MEETING #2 NOTES

- This is the second in a series of four Advisory Committee meetings for the SR 125/SR 32 Focus Area.
- This meeting is intended to be a working meeting. It will focus on reviewing the results of the preliminary studies completed for each concept discussed at the first Advisory Committee meeting; discussing possible refinements to be made to the concepts; and determining whether or not to advance each concept for further study.

Eastern Corridor Segments II and III SR 125/SR 32 Focus Area

Figure 32-4
CORRECT 'S' CURVE

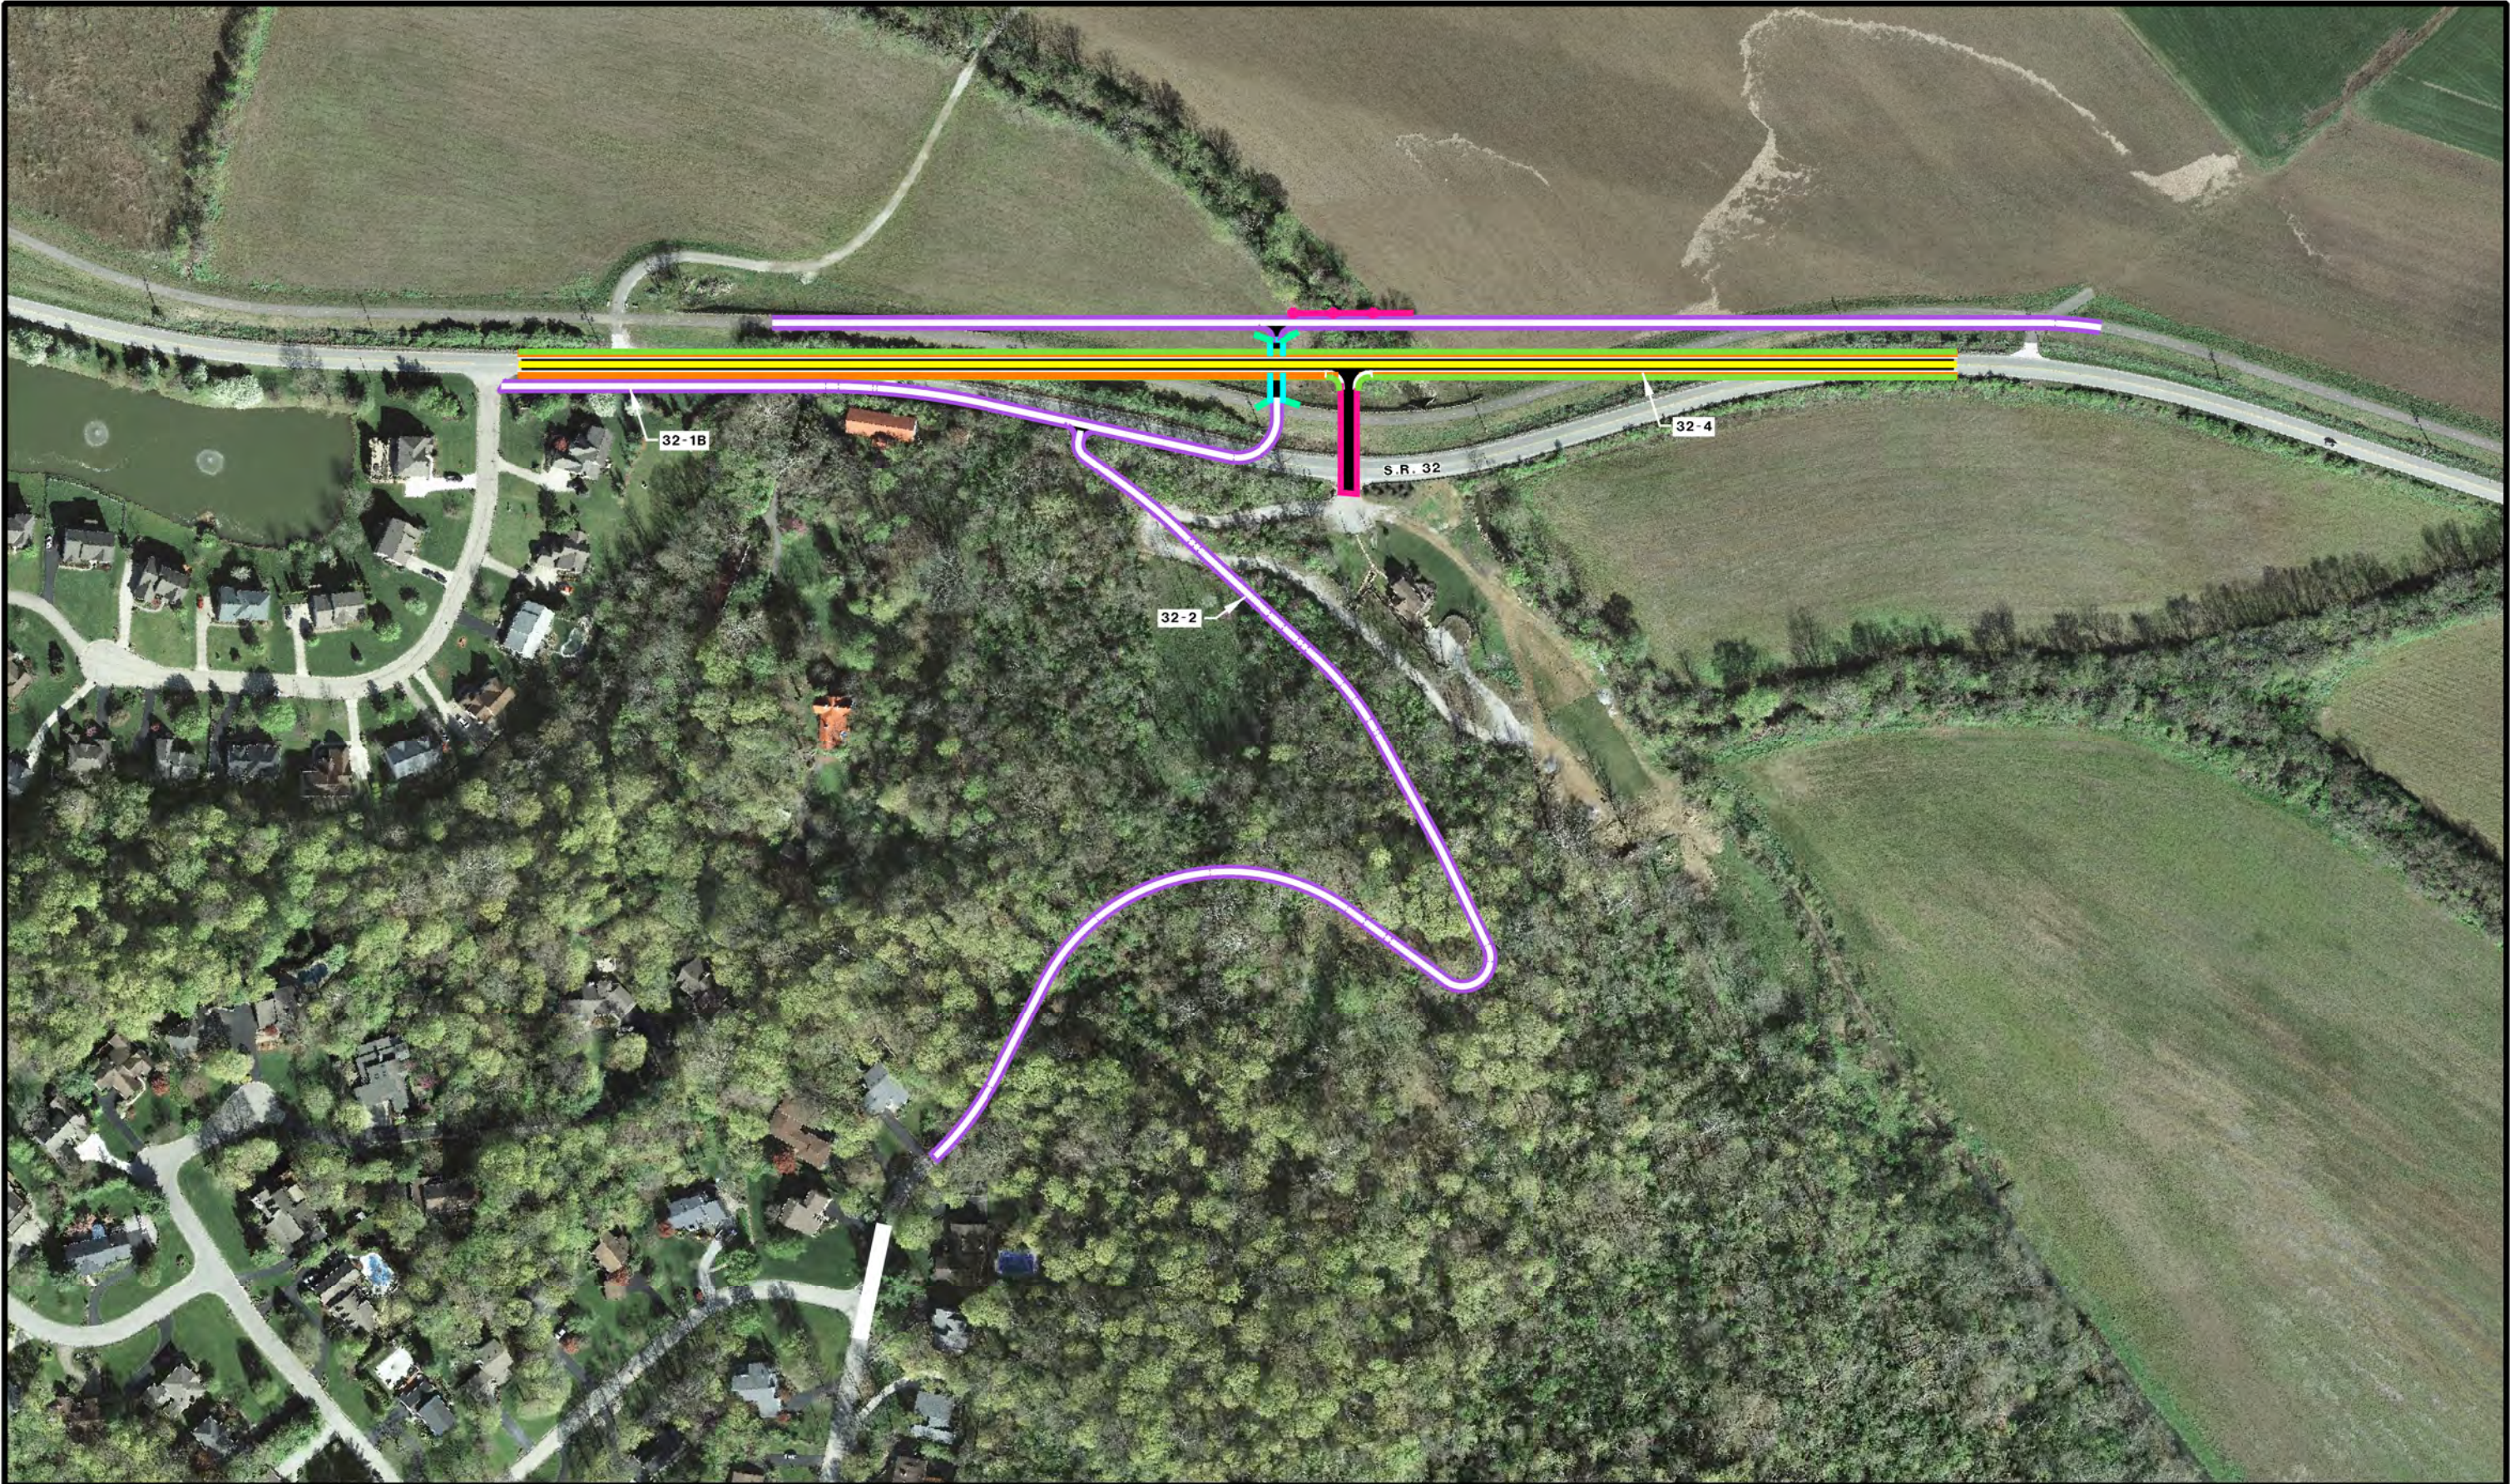
- Proposed changes would improve travel safety along the road in this area.
- Currently, flooding causes periodic closures; raising the road out of the floodplain will help alleviate this problem.

- Raising the road out of the floodplain would have an impact on nearby driveways.
- The speed limit along this stretch of SR 32 is marked as 55 mph, but only meets 45 mph design standards.

- Lowering the speed limit in this area may be appropriate; a speed study would need to be conducted to make this determination.
- Excavation would be needed to install a new culvert under the road; if desired, this project could include excavation for a new bike/pedestrian underpass as well.

- Excavation could be a concern due to cultural resources.
 - Even if an underpass is constructed, people may still access the bike path by crossing SR 32.

- Currently, this concept only looks at horizontal design; next steps would be to look at vertical design to further determine feasibility.
- Temporary paving/road would be needed during construction.

- This project can potentially include a bike path connection to the Five Mile Trail using neighborhood streets.

- Advance for further study.
- Consultant to look at whether or not a left turn lane should be added to assist vehicles with exiting the Turpin Lake residential area.

Figure I-7D CLOUGH PIKE AND S.R. 32 GREEN TEE INTERSECTION									
Safety	Traffic Operations	Constructability Issues	Construction Cost	R/W Impacts	Environmental / Community Impacts	Support and/or Facilitate Multi-Modal	Improve Regional Connectivity	Improve Local Access

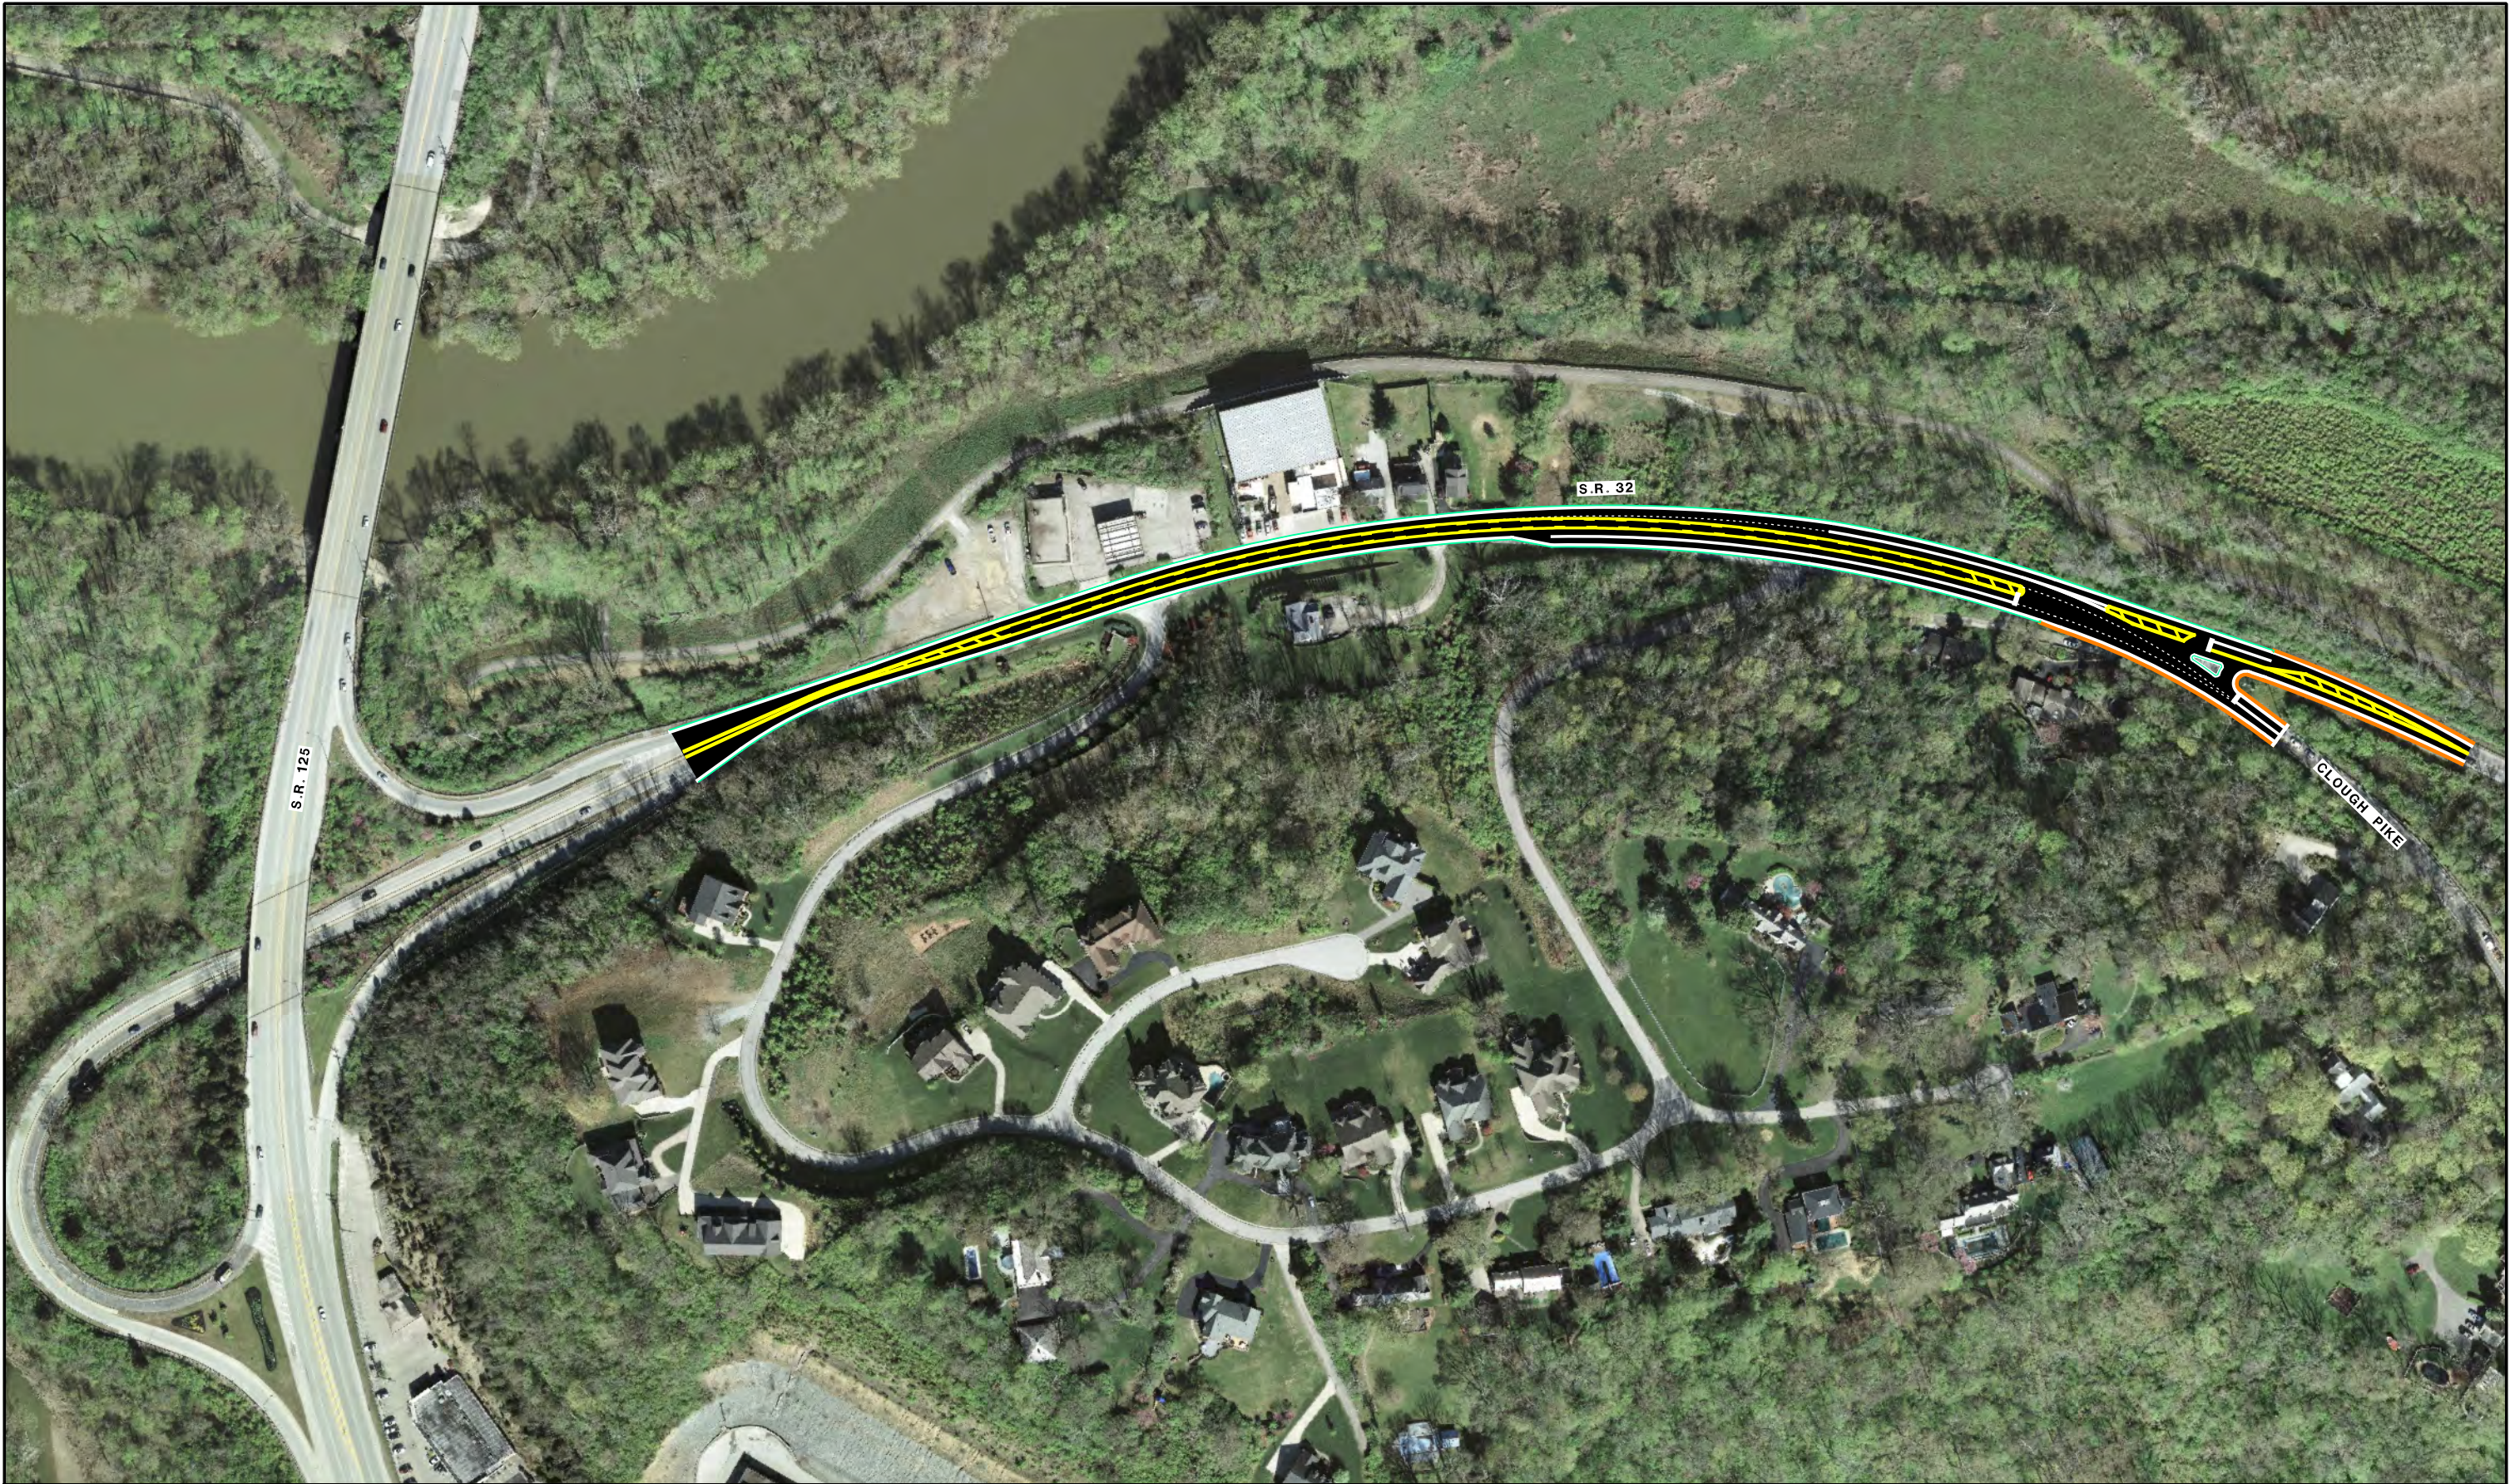
- Constructing a Green Tee intersection will allow SR 32 westbound to flow continuously.
- Concept allows for vehicles on westbound SR 32 to turn left onto Clough Pike.
- Initial studies indicate:
 - 48 percent reduction in morning peak-hour delays.
 - 5 percent reduction in evening peak-hour delays.
- This concept would require SR 32 to be widened in spots. However, the slope and geology in the area pose challenges to widening the road.
- Committee asked the consultant team to:
 - Determine if the lane for vehicles merging from Clough to SR 32 westbound is long enough.
 - Determine how access to and from Speedway will be impacted without a signal at the Clough/SR 32 intersection.

- Advance for further study.
